# SUBSURFACE WASTEWATER DISPOSAL SYSTEM APPLICATION

AUGUSTA 1-77 PERMIT # 731 TOWN COPY

| <b>CROSS SECTION = BED SYSTEM</b>         |                          |                                  |

# Replacement System Variance Request

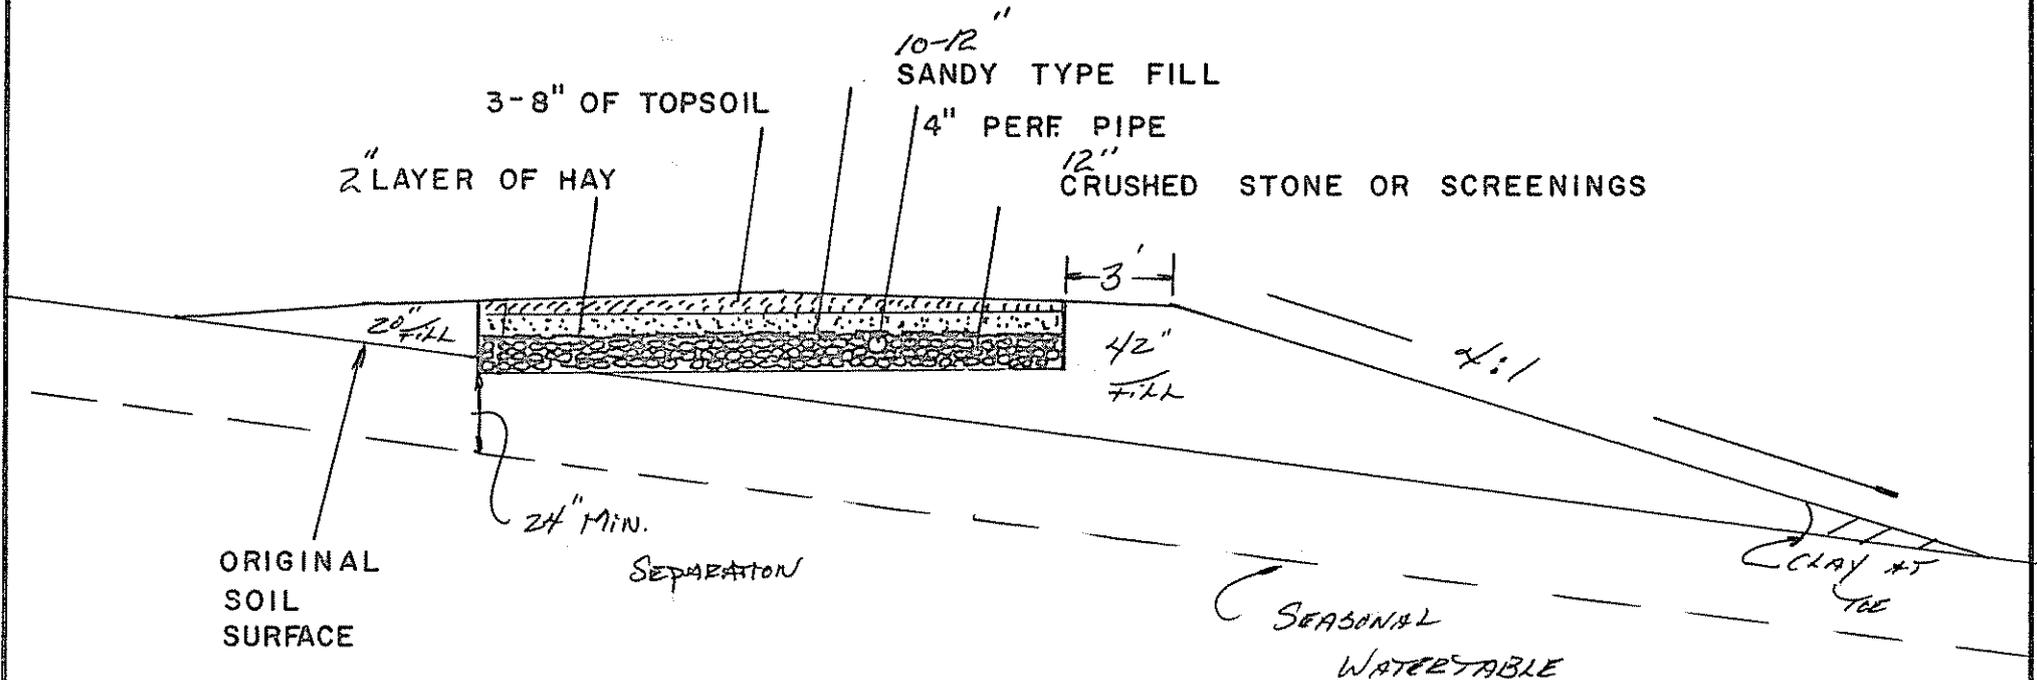
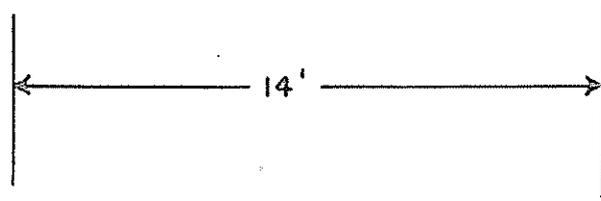
I spoke with Russ Martin today about this system.  
He states that the system is on the border line but  
can be accepted that Martin should watch to  
make sure the stone is  $3\frac{1}{4}$ " to 3" even size.
